PLAT COMMITTEE

Case Number: 2025-PLT-016
Property Address: 5244 Shelbyville Road (*Approximate Address*)
Location: Franklin Township, Council District #24
Petitioner: Nora Bastida
Zoning: D-P
Request: Approval of a Subdivision Plat to be known as ICJ Homes Subdivision, dividing 2.87 acres into 18 lots.
Waiver Requested: None
Current Land Use: Undeveloped
Staff Reviewer: Michael Weigel, Senior Planner

2025PLT016 ; Preliminary Plat

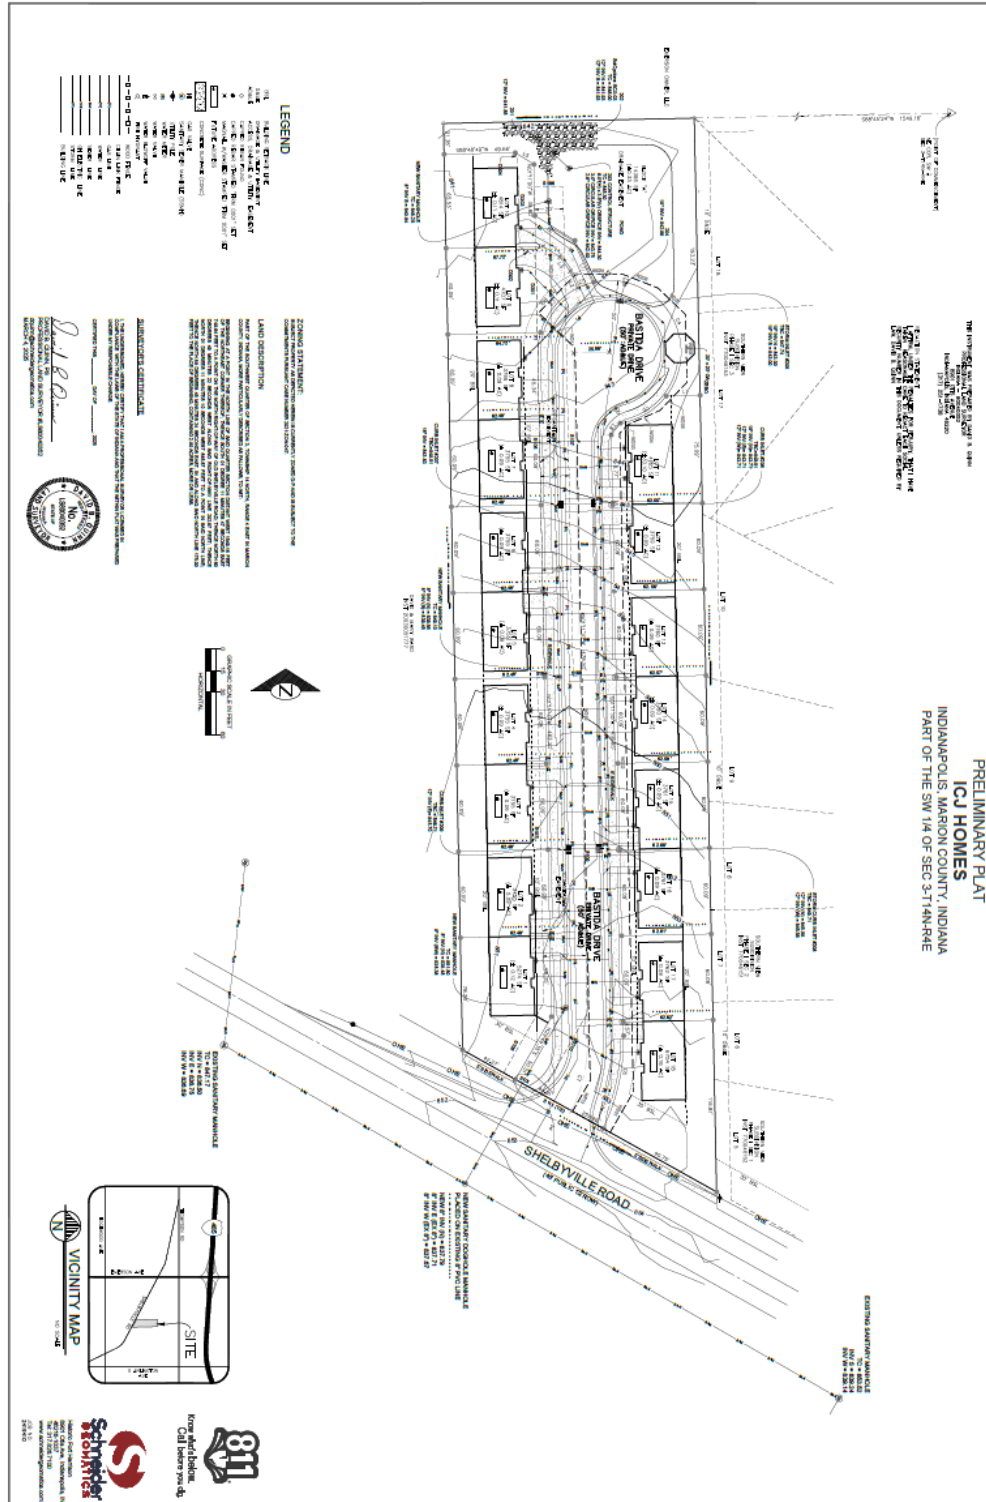
10. That the plat restrictions and covenants, done in accordance with the rezoning commitments, be submitted prior to recording the final plat.
11. That all the standards related to secondary plat approval listed in Sections 741-207 and 741-208 of the Consolidated Zoning and Subdivision Ordinance be met prior to recording the final plat.
12. That a Topographic Map and Traffic Control plan be submitted prior to recording the final plat.
13. That the final plat includes pedestrian connectivity via hatched and painted curb ramps between the two endpoints of the sidewalk near the Bastida Street gazebo along the areas of the cul-de-sac where sidewalk is not provided.

Sidewalks are required per the D-P statement and subdivision regulations and are proposed along Bastida Drive as well as the portions of the proposed plat that front on Shelbyville Road. A small portion of the cul-de-sac (northwest portion near the gazebo) does not contain sidewalk given complications related to site drainage and grading change. Although a full waiver would not be required given that Bastida is a private street and that no buildings are proposed in the area with sidewalk gap, the petitioner was amenable to the addition of a pedestrian walk area connecting the two points (see Condition #13).
